KETTLEMAN HILLS FACILITY
35251 Old Skyline Road
P.O. Box 471
Kettleman City, CA 93239

RE: CHEMICAL WASTE MANAGEMENT, INC. - KETTLEMAN HILLS FACILITY DRAFT DIOXIN-LIKE PCB CONGENERS STUDY WORKPLAN REVISION 1

Subject: Draft Dioxin-Like Polychlorinated Biphenyl (PCB) Congeners Study Workplan Technical Review

FIG. 8-28 \ ANNUAL PCB IMPACTS \ FINE RECEPTOR GRID

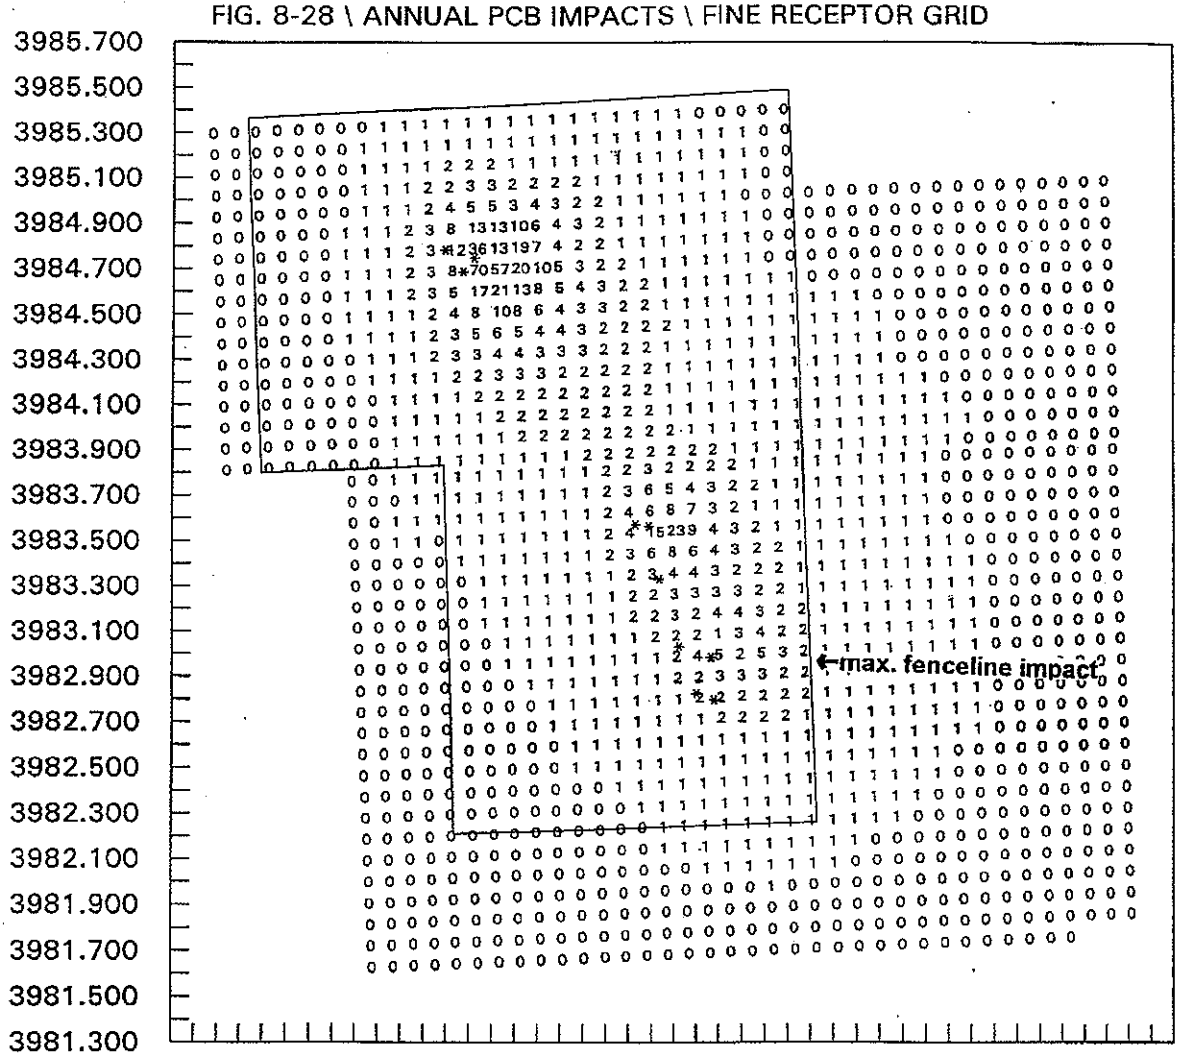
The investigational framework proposed by EPA for assessment of impacts from the current facility has attempted to incorporate several elements of this strategy. We believe several elements of the draft workplan have not adequately incorporated this overarching strategy. For instance, EPA anticipates that the enormous amount of air monitoring and meteorological data used in support of past ambient air and site-specific monitoring activities, can be effectively leveraged to support more precise site-specific

location analysis useful for the high-volume air sampling devices proposed for monitoring impacts from direct PCB disposal operations. The ability to consider landfill microclimate and air transport & dispersion characteristics unique to the PCB disposal surface offers the potential to provide critical information when assessing locations of maximal impact. Our review fully anticipated increased use of this level of data and analysis, and we believe significant efforts should be made to incorporate the facility's on-site meteorological data and the known patterns of air movement and transport to further inform the specific siting and location of the PCB congener sampling devices.

Response to comment above regarding the enormous amount of previous air monitoring and meteorological used to support the proposed locations of the proposed air sampling locations: ***An extensive effort was made by CWM and their consultant to utilize all appropriate historic data to support the design and rationale of the proposed air sampling approach and monitoring locations. Section 2.6 of the Workplan discusses the two previous studies that that had an air monitoring component focused on PCBs. As discussed in this section of the Workplan, PCBs have never been detected in the air sampled at KHF. Appendix B of the Workplan presents eight years of meteorological data collected at the facility and compares that data to data collected at the nearby Fresno airport. This comparison was made to show that annual meteorological conditions (annual average wind direction) at the facility have not changed over time. This information supports the rationale behind the proposed air sampling locations in that UMS-1 is appropriately sited to reflect background (air upwind of KHF) and DMS-1 and MSP are appropriately sited to reflect air downwind (air impacted by KHF, specifically the B-18 landfill) at the facility.***

In studies such as these it is common to use air dispersion modeling data to help site air monitoring locations in areas anticipated to have the highest potential impacts from targeted source emissions. In this case, the targeted source is the B-18 landfill. Two previous air impact studies involved air dispersion modeling as a tool to predict impacts to ambient air at the fenceline and beyond from emissions at KHF. These were the 1) 1994 Topographical, Meteorological and Airborne Contaminant Characterization Study discussed in Section 2.6.1 of the Workplan, and 2) the project work to support the recently released Draft Subsequent Environmental Impact Report (SEIR) associated with the proposed expansion of the B-18 Landfill and future construction of a new hazardous waste landfill (B-20) at KHF. An exhaustive effort was made to obtain the raw modeling data from both of these projects to use as a tool to support the siting of the proposed monitoring locations for the PCB Congener Study. In the case of the 1994 Study, the raw modeling data was no longer available because the project was performed 14 years ago, and by a company that no longer exists. However, an isopleth figure from the 1994 Study (see attached) supports the basis that MSP and DMS-1 are located in the general area of maximum air impacts from KHF emissions. Though preparation of the Draft SEIR was performed more recently, it proved to be very difficult to obtain the modeling data used to predict air impacts as the modeler who performed the analysis has since joined a different firm and the company that performed the analysis could not obtain the data in time to prepare the Workplan. In the case of the Draft SEIR modeling, the data is really not comparable anyway to the types of emissions targeted in the PCB Congener Study.

KHF is located in the Kettleman Hills on the western edge of the San Joaquin Valley which, because of the topography, is classified as complex terrain. Complex terrain has its own unique micro scale meteorological conditions that result from winds channeling in valleys, and wind currents resulting from solar heating of hillsides and valleys. Though there are air dispersion models approved for use in complex terrain, localized property line impacts such as

those targeted in the PCB Congener Study Workplan, are subject to high levels of uncertainty when predicted using a statistical based model. For this reason, it is appropriate to use common sense, field observations, and site knowledge, to locate air monitors near specific emissions sources such as the B-18 landfill. This was the basis in logic for siting the proposed air monitoring locations. Another significant factor is also the availability of power needed for the high volume air samplers required to sample for trace level PCB congeners. While power availability cannot be a reason to avoid sampling in maximum impacts areas, it is certainly a factor that must be considered. However, power is available at DMS-1 and MSP, which as shown in the attached isopleth, are in the area of maximum impact from facility emissions.

To avoid any question that the proposed monitoring sites are not appropriately located to satisfy the objectives of this study, KHF has agreed to also place a temporary PUF air sampler near the administration building (see response to Specific Comment #2 and revised Workplan), as well as conduct air dispersion modeling of particulate depositional impacts from the B-18 Landfill. KHF and its consultant will work with USEPA-IX to obtain an approved modeling protocol, perform the necessary modeling, and provide a report to USEPA-IX summarizing the modeling results as they relate to the appropriateness to the siting of the proposed monitoring locations. Based on discussions with USEPA-IX, it is anticipated that this information will be used, along with field observations and site knowledge, to verify that the proposed sampling locations are acceptably located to meet the study objectives.
